## **ADDENDUM NO. 2**

**TO: PLANS AND SPECIFICATIONS FOR STATE OF MISSOURI**

**Festus Readiness Center  
Interior/Exterior Repairs  
270 Highway P  
Festus, MO 63028  
PROJECT NO. T2330-01**

A-RC-02

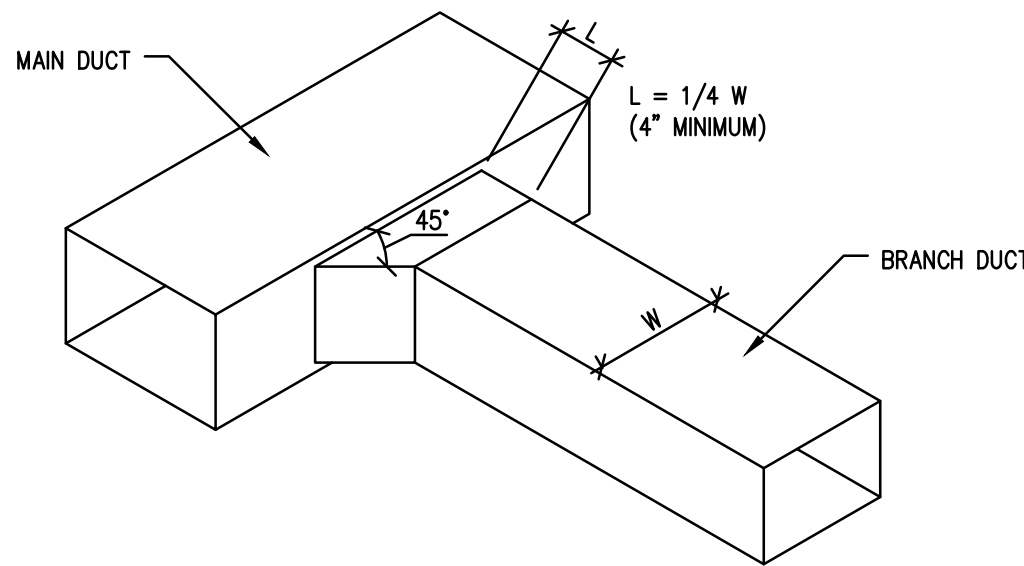
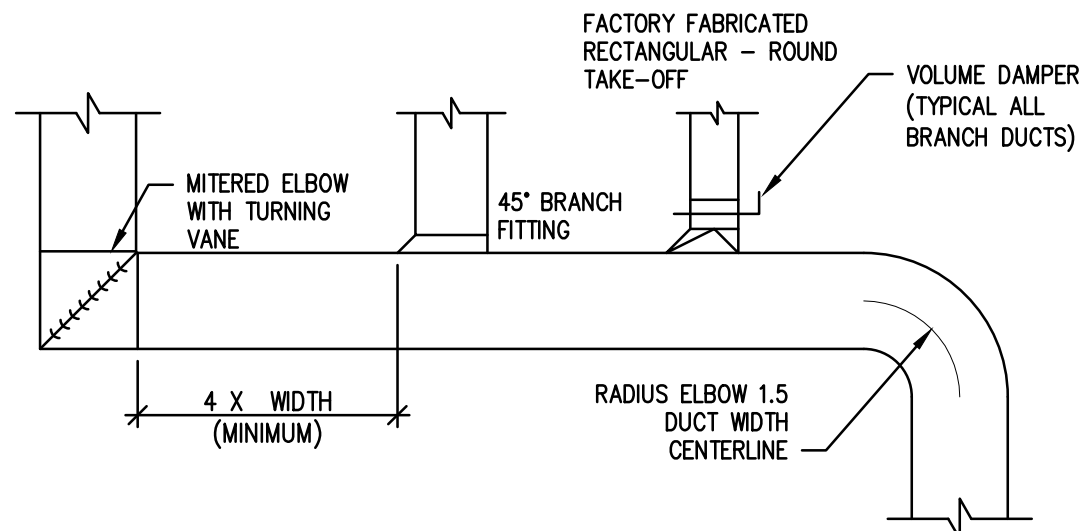
1. A-RC-02 – 2<sup>ND</sup> Floor Reflected Ceiling Plan
  - a. Area indicated for the removal and replacement of damaged
2. M-1 – Mechanical HVAC Plan
  - a. Air Device Schedule added to the drawing.

REMOVE & REPLACE DAMAGED SCRIM-FACED  
INSULATIONS.  
FINAL EXTENTS TBD. AREA INDICATED IS  
REPRESENTATIONAL OF THE TOTAL AMOUNT  
REPLACED AND NOT THE EXACT LOCATIONS. FINAL  
LOCATIONS TO BE REVIEWED WITH AND AGREED  
UPON BY OWNER.

M-1

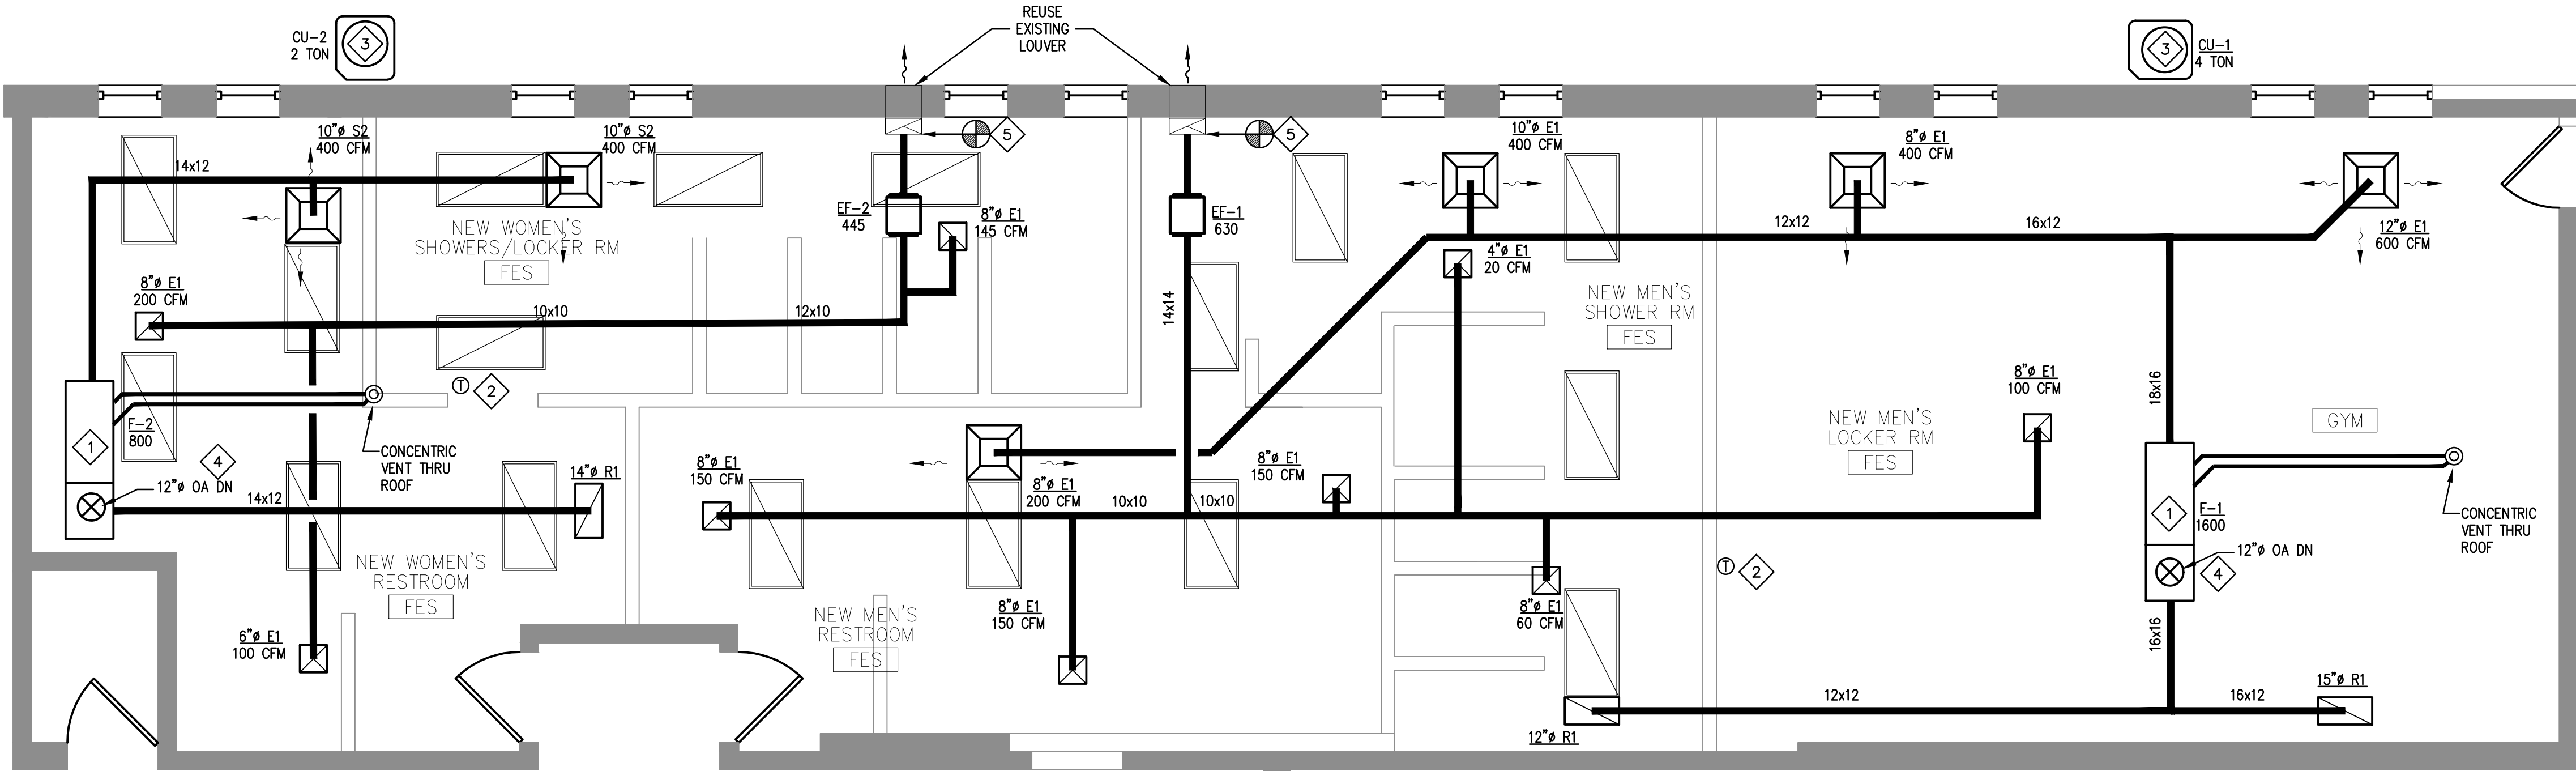
Response: There is no longer any scope of work for the unheated storage buildings.
4. The mechanical schedule sheet does not have an air device schedule. Suppliers need to know what to quote.

Response: Refer to revised M-1 with air device schedule added.

PLAN MARK	MANUFACTURER MODEL NUMBER	MODULE	MOUNT
S1	TITUS TMSAA	24X24	DUCT
R1	TITUS PAR-AA	24X12	DUCT
E1	TITUS 50F	12X12	DUCT
